NO. L. S. 7577 of 1921.

Municipal Office.

Re Plot No 175 D. G. 1. Sudder Bazar

— PLAN OF PROPOSED BUILDG —

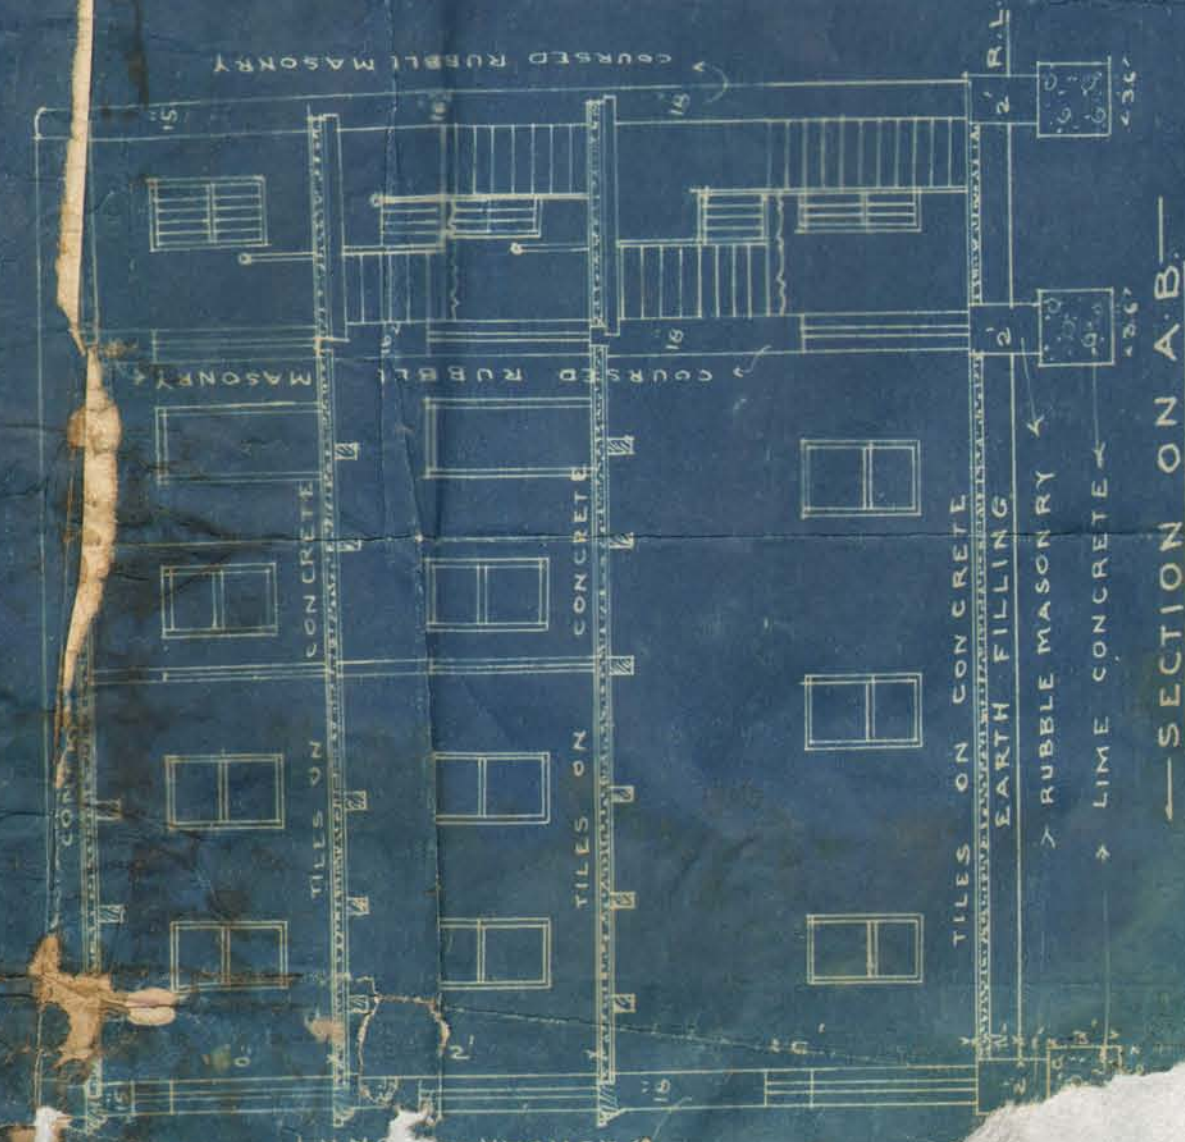
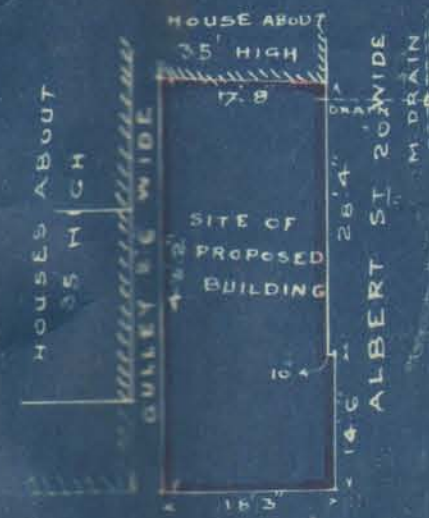
He is therefore instructed to raise the Eastern wall as shown in the plan and in the mean time insert a cross girder to support the joists of the stair hall within 3 days from receipt here-of, failing which steps will be taken under the Act.

The attention of Haji Jan Mahomed Mahomed Endik owner of plot No. 175-B, C-1 Qddar Bazar Quarter is drawn to this office letter No. 6339 dated 1st November 1920 where-in he is requested to raise the Eastern wall of the plot as shown in the approved plan.

Haji Jan Mahamed Mahamed Sadik owner of plot No. 175 D, G-1 Sadar Bazar Quarter is informed, it is observed he is not constructing the Eastern wall shown to be newly constructed in the approved plan.

He is on the contrary inserting beams in the party wall which is not strong enough to take the additional weight.

Instructions are here-by given him to stop further work at-once and to raise the Eastern wall, failing which steps will be taken under the Act.
